Missouri Department of Transportation

I-270 @ Dorsett-Page Team

Subject: Conditional Conceptual Approval – VE No. 2 (Page)
Job No.: J6U1045B
Route 364 – St. Louis County
Contract ID: 090626-601

RE: I-270/Page Avenue/MO364 Interchange Concept Evaluation
Comparison of MoDOT and Hybrid Concepts

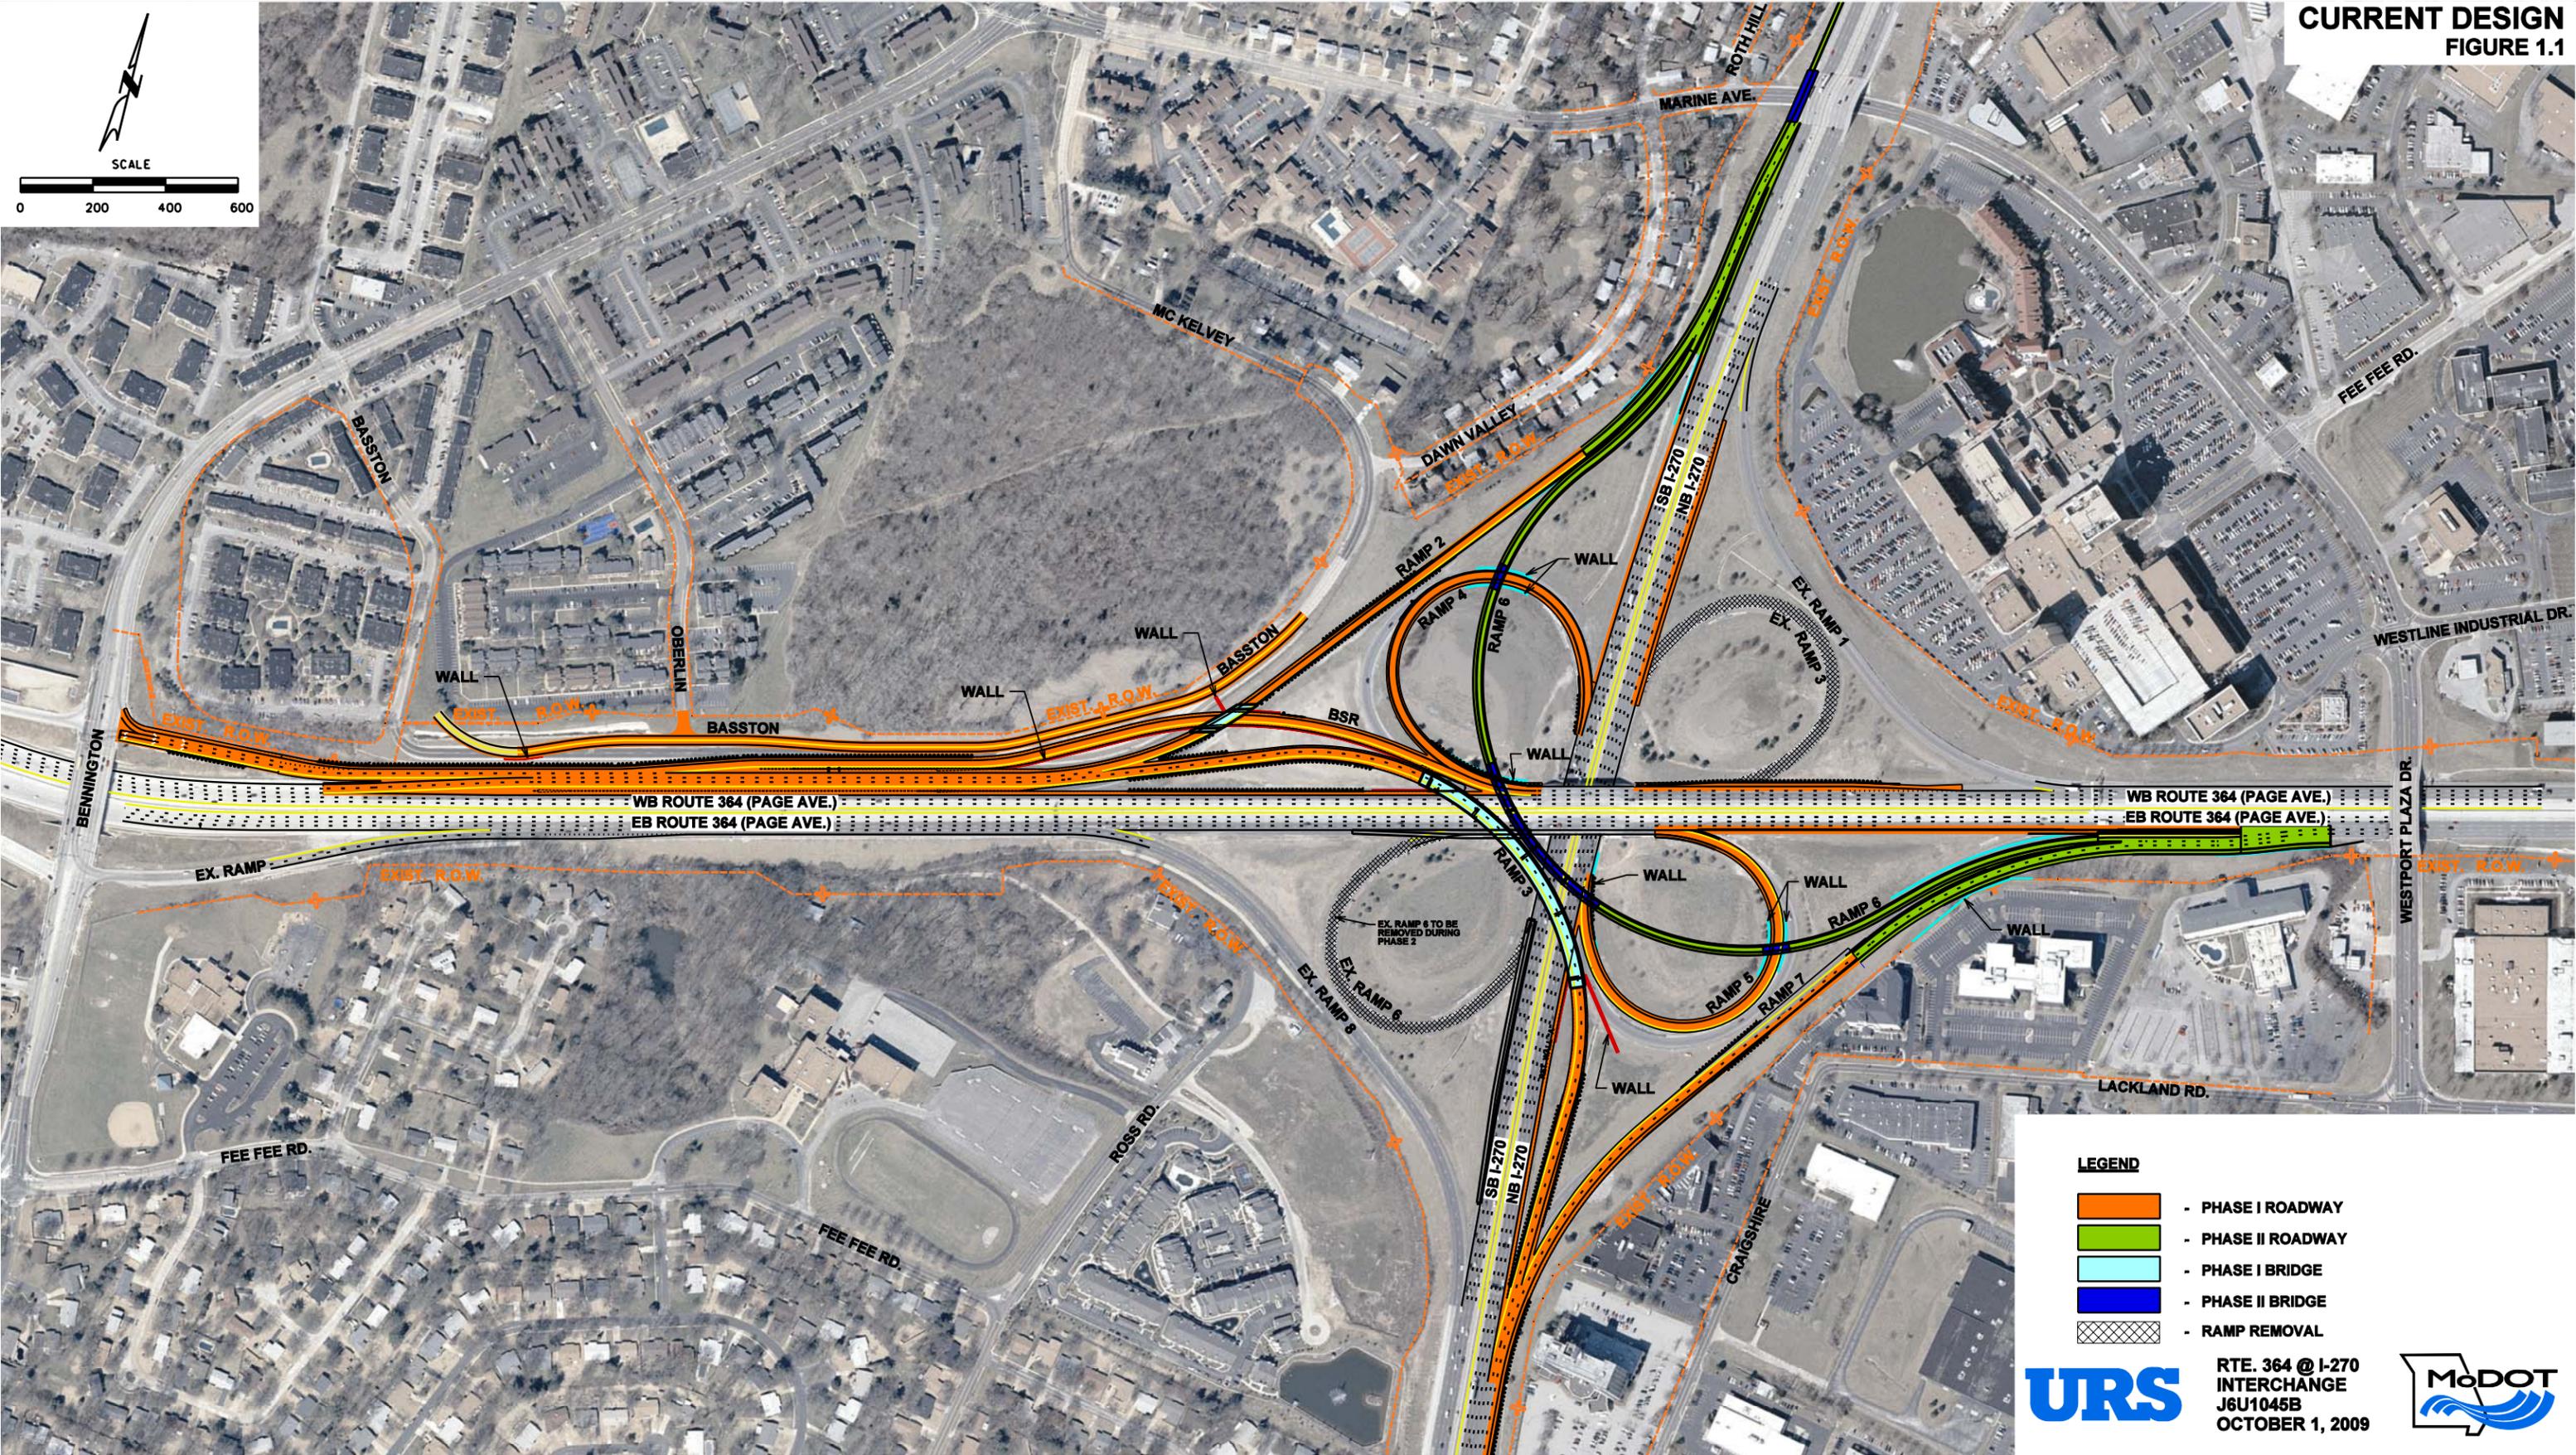
Crawford, Bunte, Brammeier (CBB) and URS has completed an analysis of various alternatives for the I-270/Page Avenue/MO364 interchange in western St. Louis County. The purpose of this memorandum is to provide a comparative summary between two concepts: 1) the original design proposed by MoDOT (Figure 1.1) and 2) a an alternate concept – Hybrid Concept (Figure 6.1).

Phase I of the current MoDOT design would replace the existing northbound to westbound loop ramp (Ex. Ramp 3) with a flyover ramp (Ramp 3). The design includes a braided slip ramp (BSR) from westbound Page aimed at bringing the traffic exiting at Bennington to the right of the northbound and southbound I-270 ramp merge points. The design also includes the reconstruction of northbound I-270 to create an auxiliary lane between Olive Boulevard and Page Avenue, resulting in a dual exit for the northbound ramps.

VISSIM analysis shows that the concept improves the operations along northbound I-270 by eliminating the weaving movements along northbound I-270, between existing Ramp 3 and existing Ramp 5 and westbound Page Avenue between existing Ramp 3 and existing Ramp 4. This alternative improves the LOS on northbound I-270 south of Page Avenue from D to C during the AM and PM Peak Hours. Additionally, the average speed on this segment increases by approximately 20% (10 mph) during the PM Peak Hour from about 50 mph to 60 mph. The Collector-Distributor road segment along westbound Page Avenue operates at LOS A during the AM Peak Hour and LOS B during the PM Peak Hour.

RTE. 364 @ I-270
INTERCHANGE
J6U1045B
OCTOBER 1, 2009

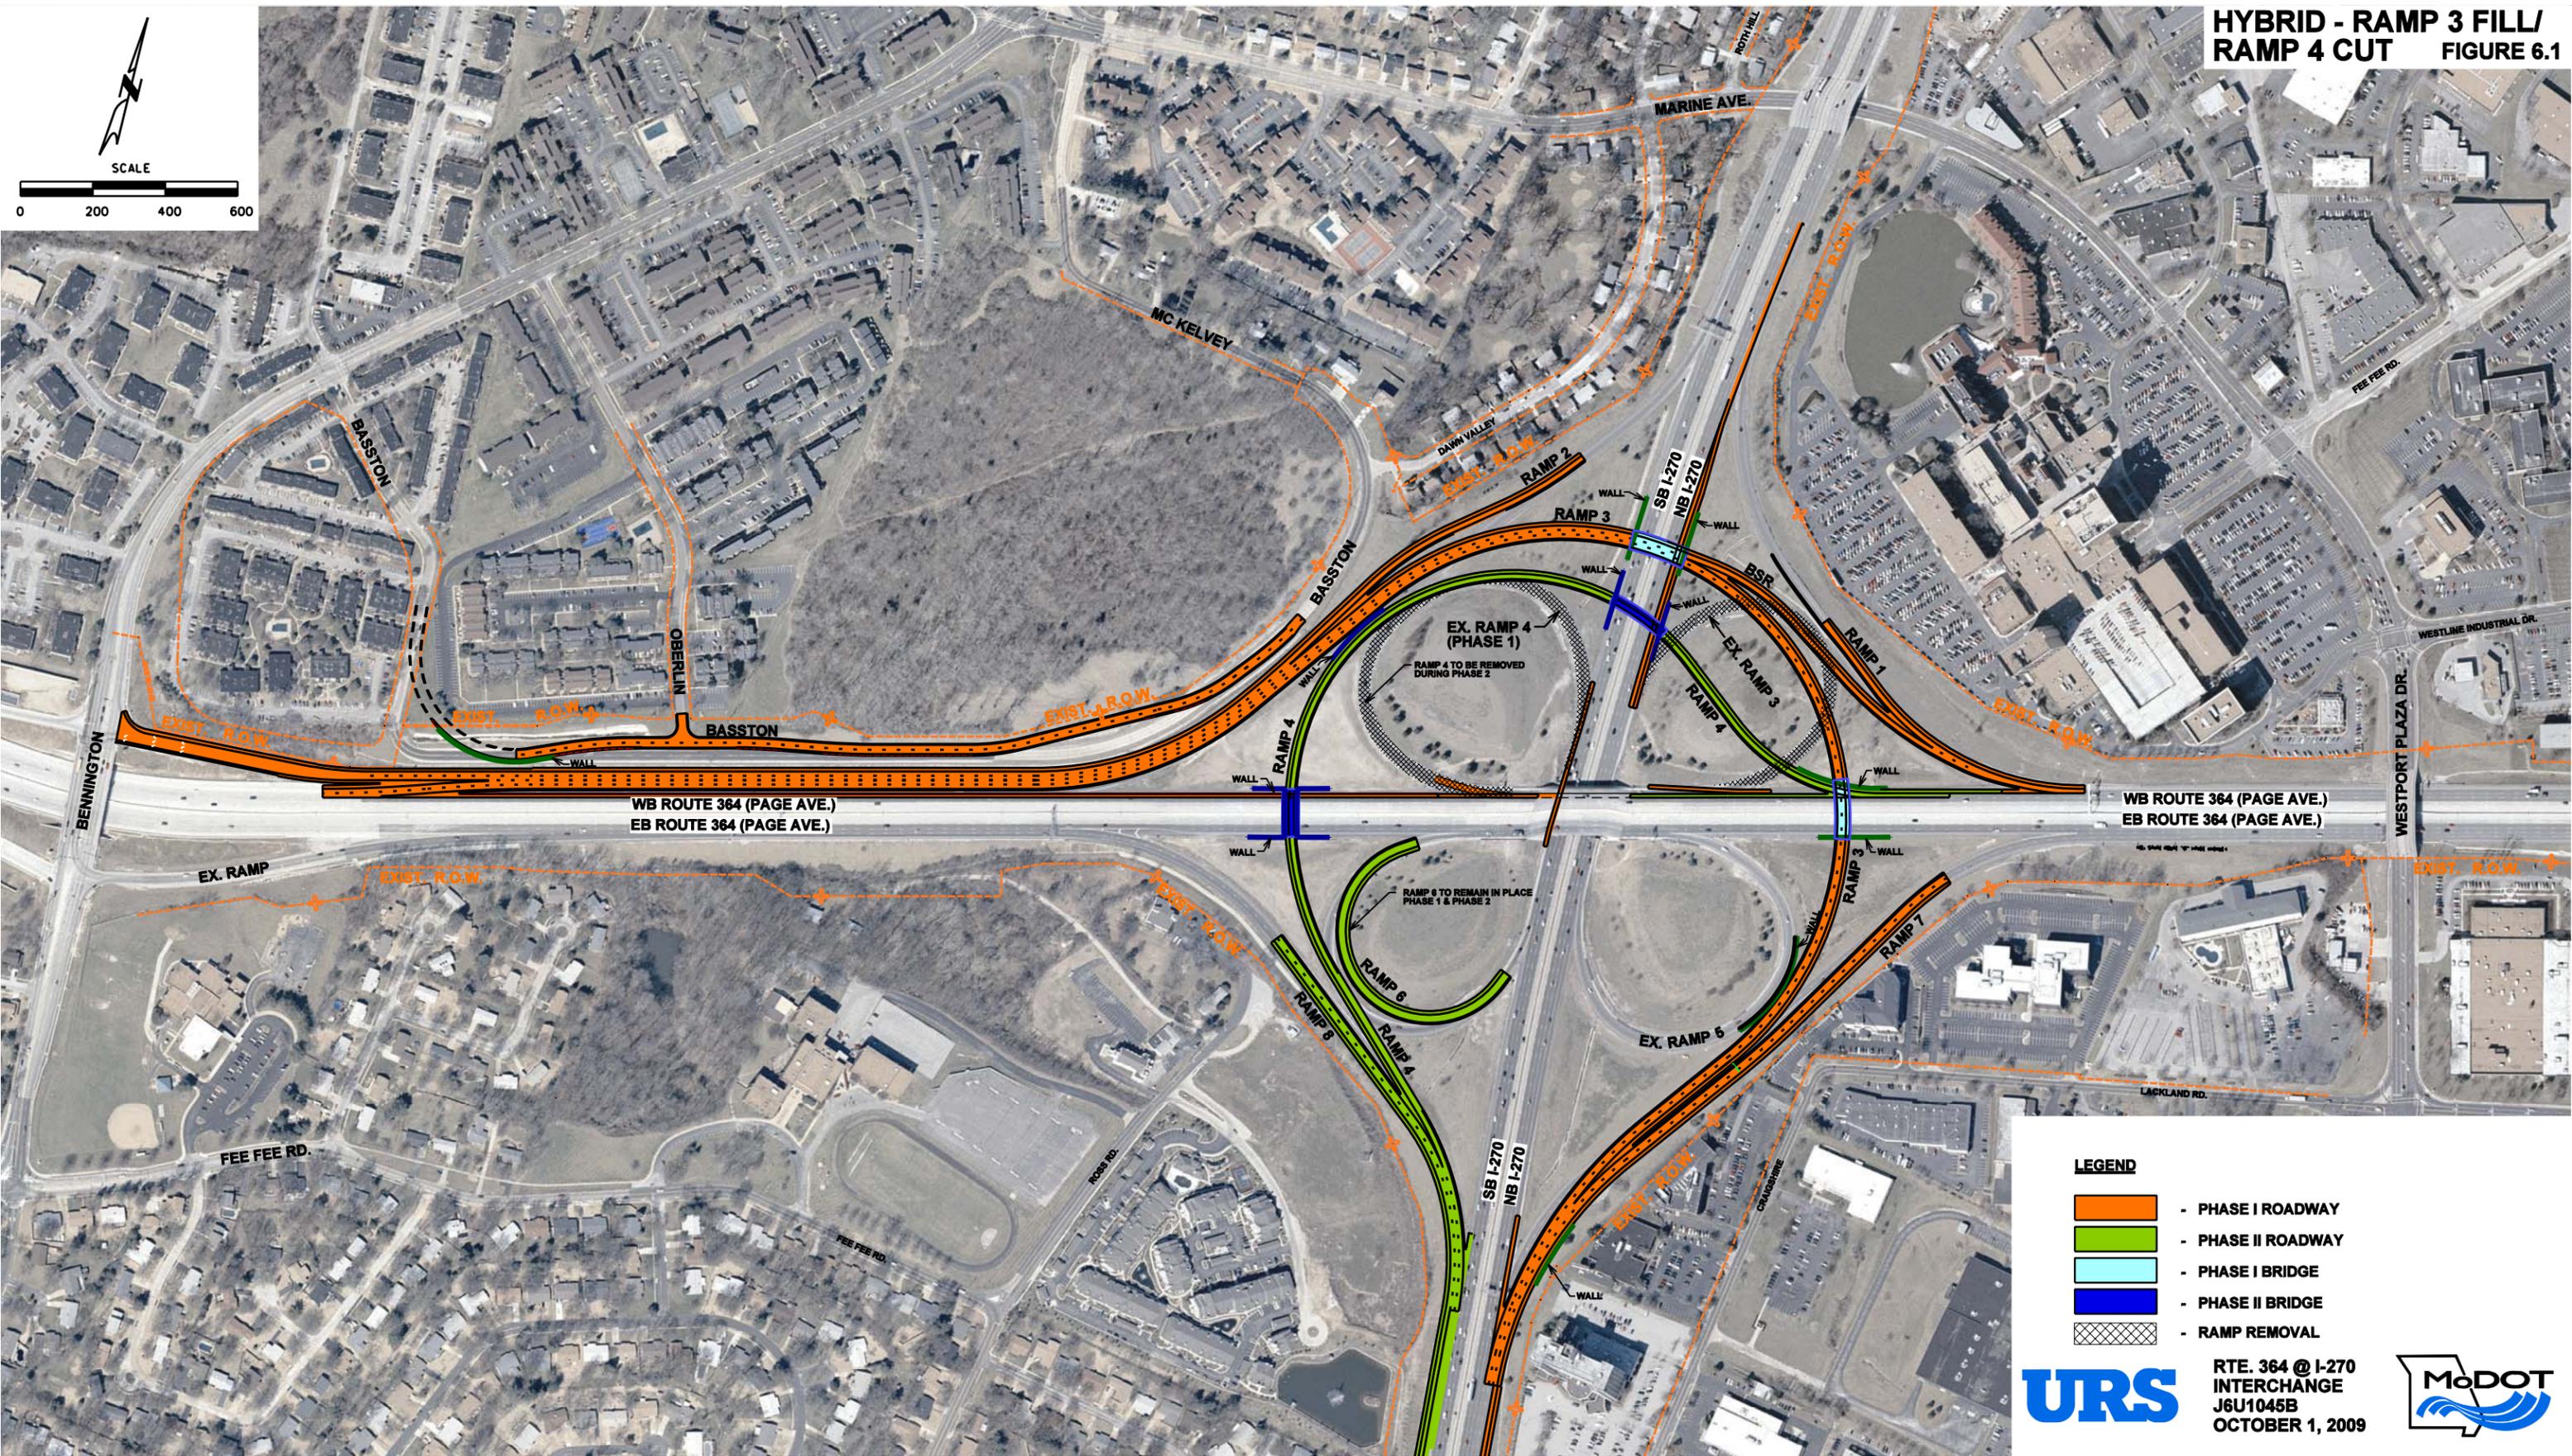
The Hybrid concept provides similar movements and benefits as the MoDOT design. One major difference is that the westbound BSR ramp is relocated east of I-270. The result is a minor weave between the Ramp 2 traffic and the BSR traffic. This would be a “type C” weave with the Ramp 2 traffic being required to make two lane changes to reach westbound Page Avenue. BSR traffic would not be required to make any lane changes. Critically, however, the Ramp 3 traffic could travel through the interchange without making any lane changes, making full use of both lanes. The weave section would operate at LOS A in the AM peak period and LOS B in the PM peak period with 2030 traffic. This represents no change in LOS from that of the current MoDOT design

This weave is acceptable for a couple of reasons. First, weaving volumes are relatively low. The projected 2030 PM peak traffic on Ramp 2 is 1300 vph. However, origin-destination counts taken over the past several years show that about one-half of this traffic exits at Bennington. The 2030 PM peak BSR traffic is projected to be less than 400 vph – allowing for ample gaps for the Ramp 2 traffic. Moreover, weaving would occur on a CD road (and thus in an environment anticipated by drivers). In summary, the Hybrid concept provides very similar traffic operations as compared to MoDOT’s original concept.

The addition of lanes, Bennington Slip Ramp and Ramp 2, along the outside of Ramp 3 horizontal alignment are a change from the current design. Typically, when ramps merge with freeways, longer acceleration lengths are recommended. Given the lower speeds of Ramp 3 and the converging Ramp 2 and Slip Ramp, this alignment functions more as Collector-Distributor road than a high-speed directional ramp. Additionally, only motorists on Ramp 2 wishing to travel westbound on Page will need to change lanes, keeping all remaining movements in their current lanes.

Phase II of the Hybrid concept would construct a westbound to southbound flyover ramp (Ramp 4) instead of the southbound to eastbound flyover ramp (Ramp 6, Current MoDOT design). The interchange's heavier traffic movements are all to and from the south, and this change would provide for directional ramps for all of these movements. The 2030 peak period traffic forecasts to and from the south are shown below.

Another difference of the hybrid design is that it maintains the current weave on eastbound Page Avenue over I-270. Thus, the existing "type A" weave would be maintained, with both traffic streams being required to make one lane change. With 2030 design traffic this weave segment would operate at LOS C in the AM peak period and LOS A in the PM peak period, which is an acceptable condition. Again, weaving volumes are relatively low. The critical time period is the AM peak where the 2030 forecasted traffic volumes are 1,260 vph for the Ramp 6 movement and 1,080 vph for the Ramp 5 traffic movement. Overall, this concept provides similar traffic operations compared to MoDOT's original design plan.
